Historic Architectural Review Commission Staff Report for Item 16

Application Number: H2021-0037

Address: 917 Duval Street

Construct second-story addition on top of existing concrete block structure. New roof deck garden/common area.

Proposed second and third floor plans.

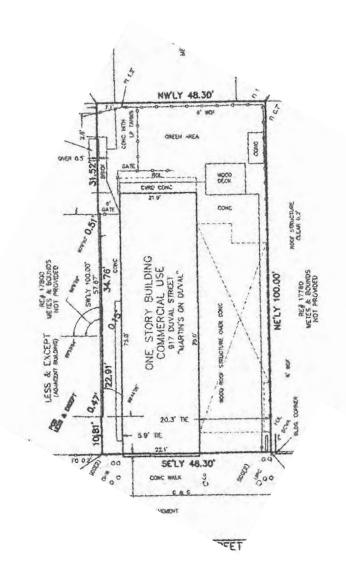
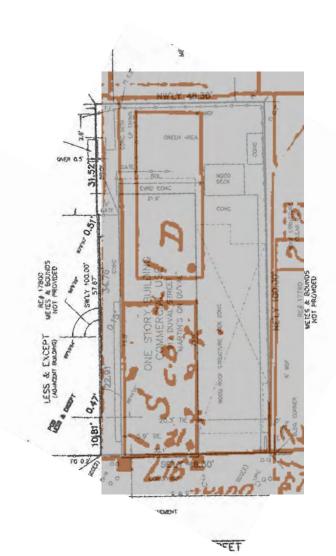
The proposed third roof is not equally proportioned setback from the second story roofline on its four sides. The west and east walls on the proposed third floor are flush to existing walls and north and south walls have different setbacks from existing exterior walls, therefore this is a third floor and not a half story. The following drawings include setback arrows depicting same sizes proposed setbacks – north/ south and east/ west sides:

DUVAL STRET ELEVATIONS
PROPOSED

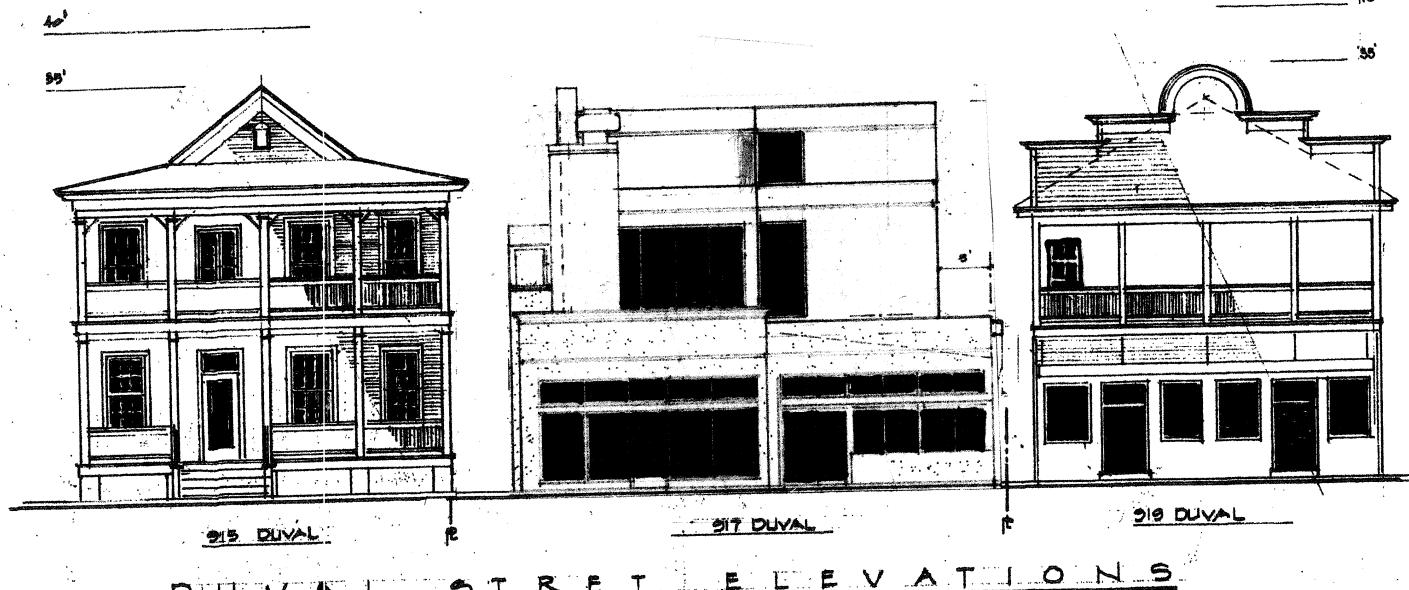
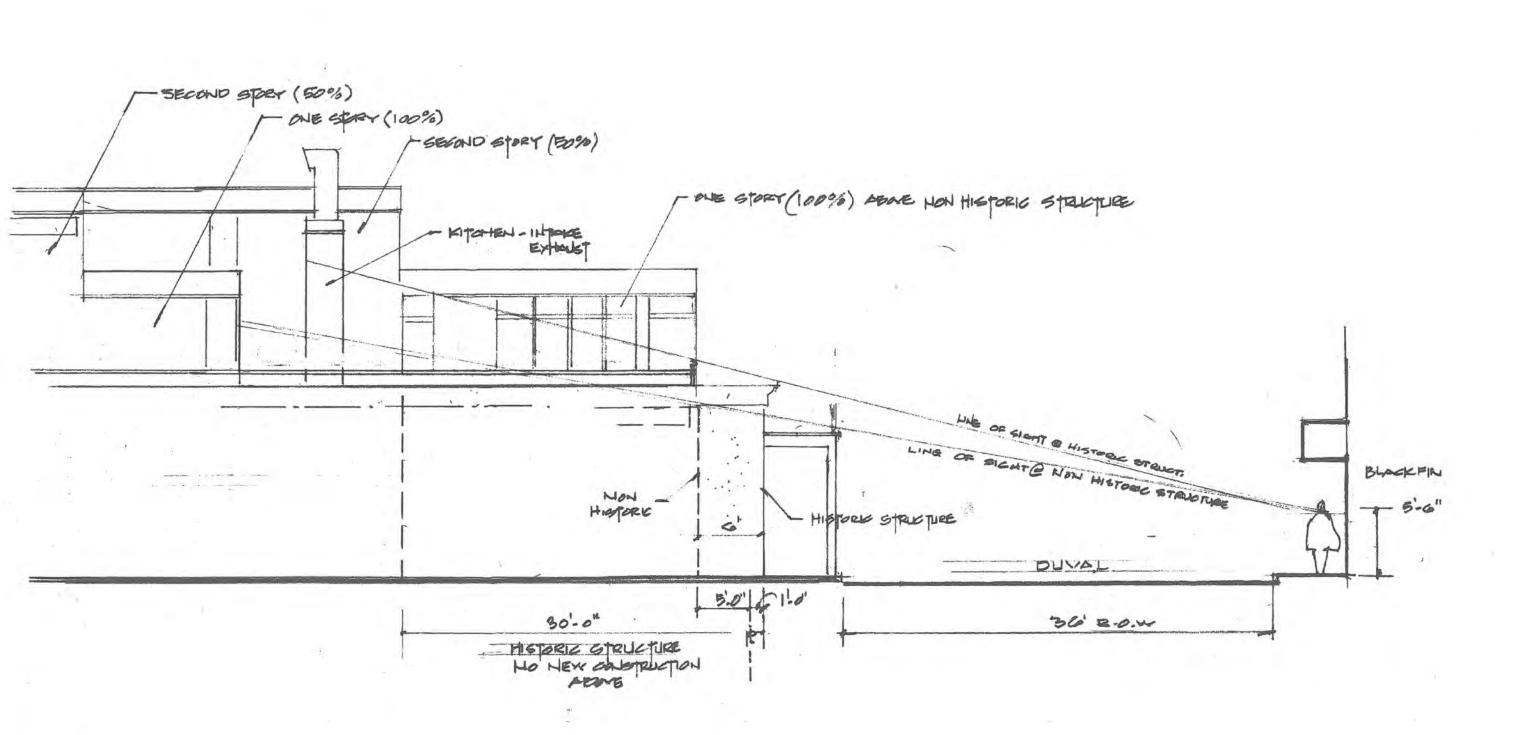
It is staff's opinion that the proposed plans fail many of the cited SOIS and guidelines. Scale wise the proposed second floor will be taller than the existing building. This and the treatment of an almost no fenestration front elevation facing Duval Street makes the existing non-historic side main façade almost crushed over such a solid volume. The proposed rhythm, and void and solid ratio of the new structure disharmonizes with the transparencies find not only in the existing

building' front facades, but in adjacent historic buildings that have porches on their second floors. Staff finds that the proposed plans are depicting a three story-building, which is prohibited by HARC regulations, that has its own scale, mass, proportions, forms, and architectural vocabulary that completely unrelates to the historic surrounding context. Staff finds the proposed additions foreign to the surrounding urban context.
